Subject: New Cascadia Aluminum Battery Cable Replacement

Models Affected: New Cascadia Vehicles without Cummins engines or in-rail battery boxes built from 11/26/2018 to the present

CAL FTL 54-018

(Preliminary work for recall FL893/NHTSA 21V-481)

Fig. 1, Battery Cable Access Location

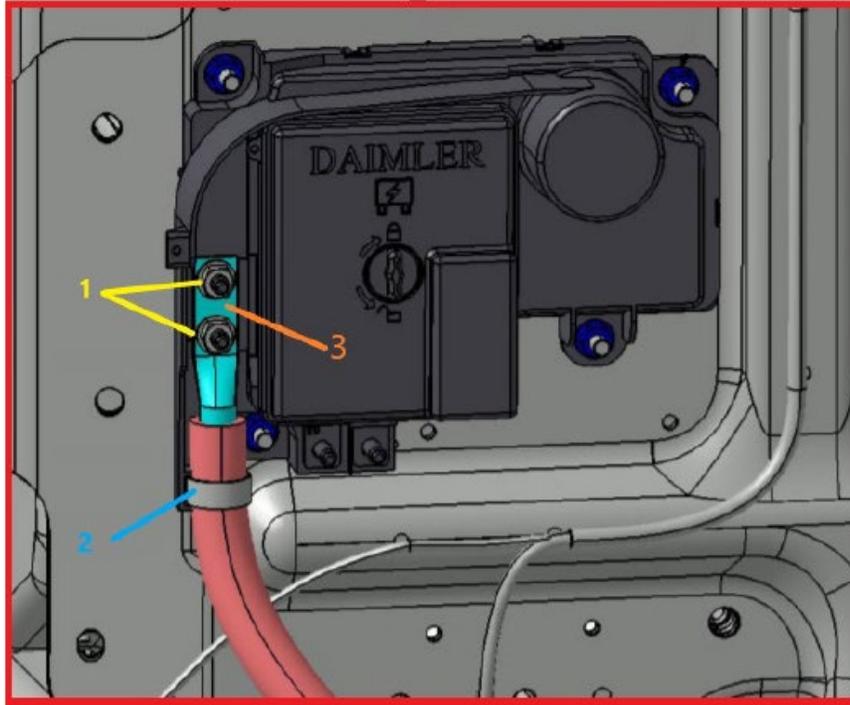
The work instructions below describe the replacement of four aluminum battery/powernet cables with copper equivalents and the installation of an updated DK clamp (part number 23-13454-001). The four cables are located in the following modules: 281, 29A, 291, 49U, 49V, 49W, and 49Y.

7. Locate the two studs that secure the main positive 29A cable to the BCA. See callout 1 in **Fig. 1**. The 29A cable may be covered in a red dielectric coating.

8. Hold the ends of the studs in the non-threaded area with vice grip pliers to avoid the stud spinning in the case of the BCA during removal.
9. Using a 13 mm box end wrench, turn the nuts counterclockwise to remove them from the studs.
10. Remove the 29A positive cable and set it aside.
11. Replace it with the appropriate copper cable from the crossover parts list.
12. Replace the nuts on the stud with fresh stainless steel patchlock nuts (part number 23-14592-008) or non-patchlock stainless steel equivalent. Apply a drop of LOCTITE® Blue 242 to the area of the studs the tightened nuts will overlap.

13. Hold the end of each stud with a vice grip pliers and tighten each nut to 10.3 to 11.8 lbf•ft (154 ±1 N•m) with a 13 mm box end wrench to secure the newly installed copper cable to the BCA.
14. Install the new DK clamp (part number 23-13454-001) to keep cables properly routed.
15. Please present your respective field service representative with any aluminum cables replaced that have not failed. Please label cables as belonging to one of the following categories:
 - a. Below 100K miles of service.
 - b. From 100K to 250K miles of service.
 - c. Over 250K miles of service.
